MONTGOMERY COUNTY HISTORIC PRESERVATION COMMISSION
STAFF REPORT

Address:	7 Philadelphia Avenue, Takoma Park	Meeting Date:	6/14/2023
Resource:	Contributing Resource Takoma Park Historic District	Report Date:	6/7/2023
Applicant:	Brendan Casey (Alexis Hawkins, Agent)	Public Notice:	5/31/2023
Review:	HAWP	Tax Credit:	N/A
Permit Number:	1029926	Staff:	John Liebertz

PROPOSAL: Solar panel installation.

Figure 4: Solar panel layout submitted by the applicant. Source: IPSUN Solar

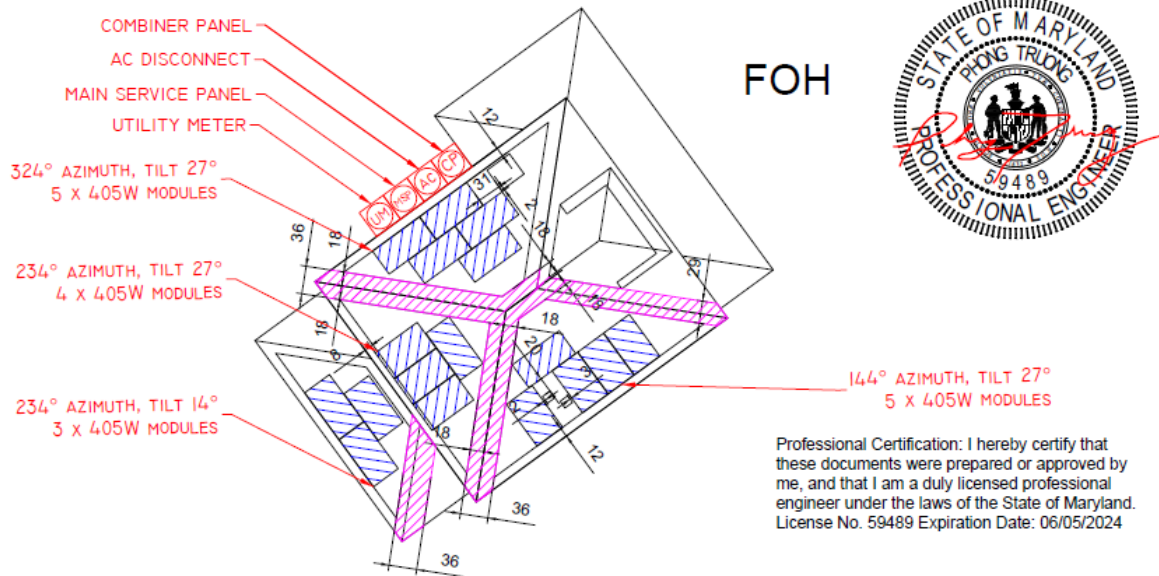
1. The applicant shall submit an amended drawing that illustrates the setback of the panels from the rake of the one-story addition.

Staff finds that the proposal meets the general guidelines outlined in *Policy Guidance #20-01: Solar Technology (2021)* for traditional roof-mounted solar panels and recommends approval with a condition. The guidance states that roof-mounted panels should: 1) have a low-profile and be mounted less than or equal to six inches above the surface of the roof (to the face of the panel); 2) be consistent with the existing slope of the supporting roof; 3) be setback from the edges and ridge of the roof; and 4) be arranged in an organized configuration and avoid disjointed or multi-roof solutions. The proposed arrays have a low-profile and the face of the panel would be less than or equal to 6-inches above the roof. The panels would be setback 36-inches from the ridge of the roof, 12-inches from the rake of the roof on the side elevations, and 8-inches from the rake of the roof on the rear elevation of the original house. This would allow the hipped roof to continue to express its form. The submitted drawings show, but do not clearly label, that the panels would be setback approximately 12-inch from the rake of the roof on the one-story rear addition. Staff recommends the applicant amend the drawing to confirm this setback. (Figure 4)

2. The applicant shall submit an amended drawing that illustrates the setback of the panels from the rake of the one-story addition.

Figure 5: Three Outstanding Resources (called out in red) in proximity to the subject property (noted in blue). Source: Montgomery Planning.

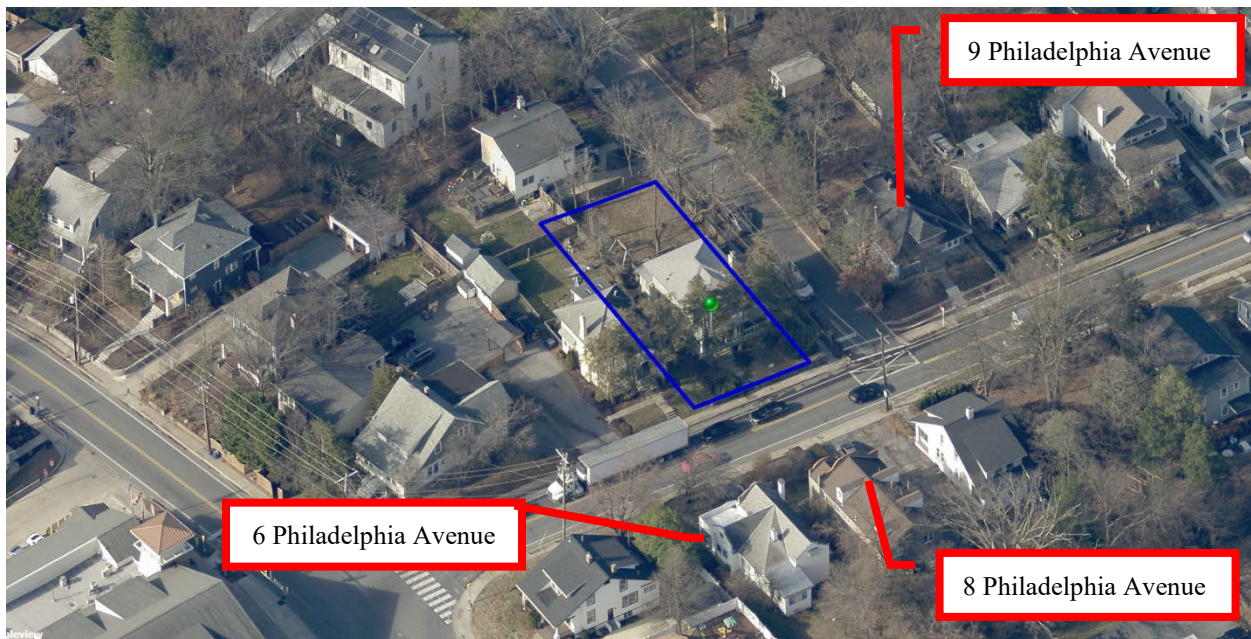
While there are three Outstanding Resources with views of the subject property, there would be limited visibility of the solar arrays (Figure 5). The houses at 8 and 6 Philadelphia Avenue are located across the street and face the façade of the subject house (absent of any solar panels). The house at 9 Philadelphia Avenue is separated from the subject house by Holt Place. Staff finds that the panels will not adversely affect the streetscape
